Interactive comment on “Morphological effects of vegetation on the fluvial-tidal transition in Holocene estuaries” by Ivar Lokhorst et al.

Ivar Lokhorst et al.

Received and published: 26 July 2018

Fig. 1. Relative vegetated width along the estuary averaged for nine natural estuaries compared to the simulation with mud and vegetation.

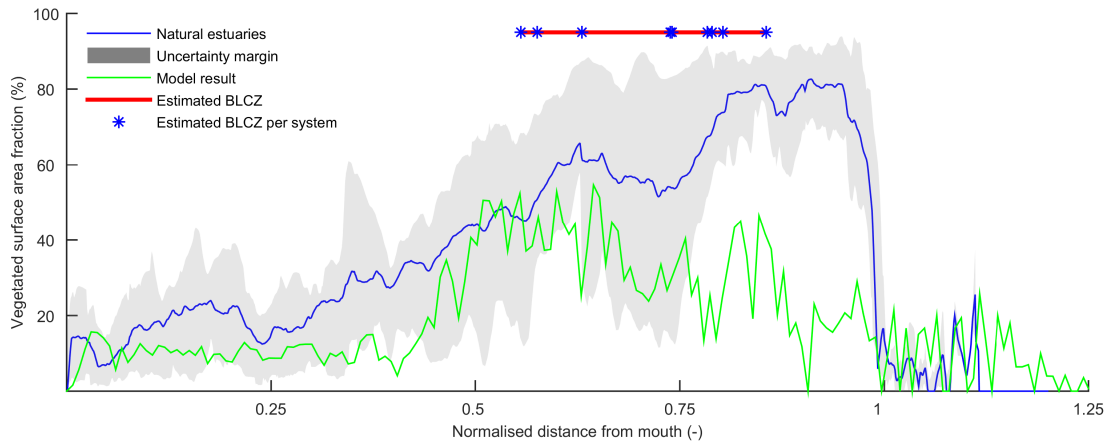
The second main comment was to plot an envelope around the width-fraction of vegetation for the natural systems to obtain a sense for the variability in the data. We added this envelope to figure 13 (Figure 1 in this reply), which now shows that our findings are fairly consistent between natural estuaries. We used the 20th and 80th percentile and plotted this around the modelled data which shows there is definitely some variability, also due to a spreading in where the BLCZ occurs, but the main trend remains clearly visible.
